# REPORT of SURVEY for REPAIRS, &c.

71686 21712 on the ~~AKAGI MARU~~ Steel S/S "HARUNASAN MARU"

REPAIRS, OR EXAMINATION AS PER RULE, FOR PART SPECIAL SURVEY 2ND NO.3, & SRL.

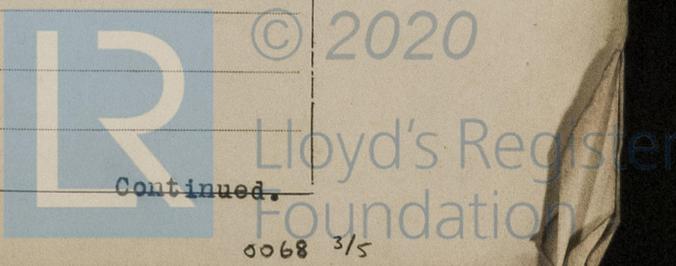
91 rust bound shell angles of side stringers renewed, viz:-

P	S
In No. 1 Hold	7	8
" " 2 "	4	3
" Side bunkers	-	-
" No. 3 Hold	8	9
" " 4 "	23	29
